CERTIFICATE OF APPROPRIATENESS

Property: 1808 State Street, Lot 7, Block 441, Baker W R NSBB Subdivision. The property includes a historic 936 square foot, one-story wood frame single-family residence situated on a 5,000 square foot (50' x 100') interior lot.

Proposal: Alteration – Revision. Replace the remaining original window (located under the porch (known as ‘Window G’)) with a 4-over-4 double-hung wood window (matching the exact dimensions and to previously installed new windows) and replace the existing non-original secondary front door with a custom wood door to match the original primary front door.

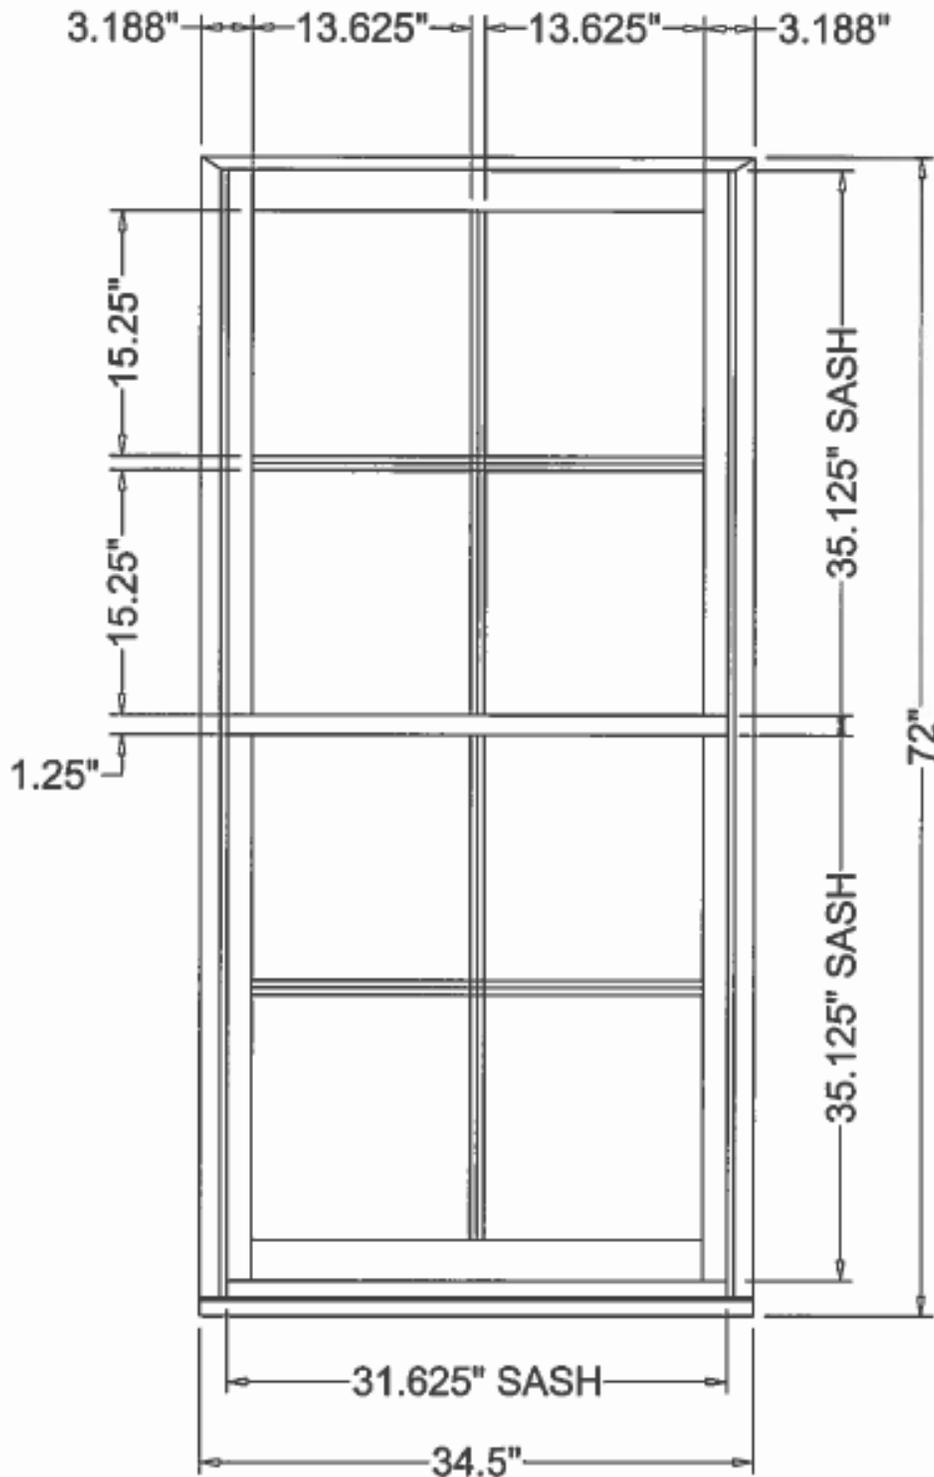
Second, we do oppose replacing the front window. Moreover, we believe that we find ourselves in this situation because of the city's reluctance to enforce its own rules.

City inspection and our neighborhood site visit confirmed that existing windows were in rough shape, but repairable. Many windows lacked sashes, but we argued that the applicant could get duplicate matches made. Alternatively, the applicant could combine sashes and partial windows and produce at least a few fully-original, working windows.

Now, the applicant would like to replace the lone, surviving, street-facing window. When the city and neighborhood inspected this window during the earlier application, we all noted that this front window was in better shape than the others. We now feel unsure why the applicant says this window's in irreparable shape. Is it the same window? During the earlier inspection, we noted that the front window and side windows were of slightly-different dimensions.

We would have accepted repairing some windows and perhaps replacing some. Instead, this applicant has replaced all but one, and is on the verge of needlessly replacing the last historic window. Why has the city not enforced its own rules? Why has the city not referenced earlier inspections and insisted on repairs rather than replacements?

HAHC Action: Partial Approval: Approval to replace the door; Denial to replace Window G.
